ADDENDUM I

SUBJECT: Formal Invitation for Bid (IFB) for FY25 – FY26 Purchase of Trailers, (IFB 6100019168),
Scheduled to Close: Monday, August 18, 2025; Date of Issue: Friday, August 1, 2025

**THIS NOTICE SHALL SERVE AS ADDENDUM NO. I - TO THE ABOVE REFERENCED
INVITATION FOR BID**

(Vendor Submitted Pictures)

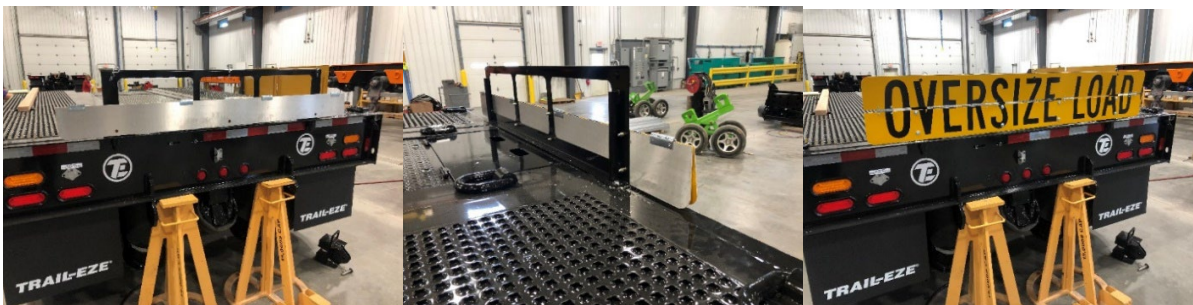
Question 15: Under Item 9 Section 4.11.12 DOT Required Signage, this calls for a fixed permanent 24" x 48". We have a standard option for an approx. 12" x 72" aluminum, folding, removable OVERSIZE LOAD sign. If we make a fixed permanent sign as requested, you would never be able to flip up a flip axle if you ever add one in the future. Can we go with our standard one as shown in the photos provided?

Section 4.11.12 is changed to read:

4.11.12 DOT REQUIRED SIGNAGE: A rigid removeable or affixed "WIDE LOAD" sign that is a minimum of 5-feet wide in length and minimum 12-inches high. Sign shall have a yellow background with black letters, will be attached across the back of trailer. Trailer color shall be black with conspicuity tape along sides and rear of trailer.

Response: Please see revised 4.11.12 DOT Required Signage.
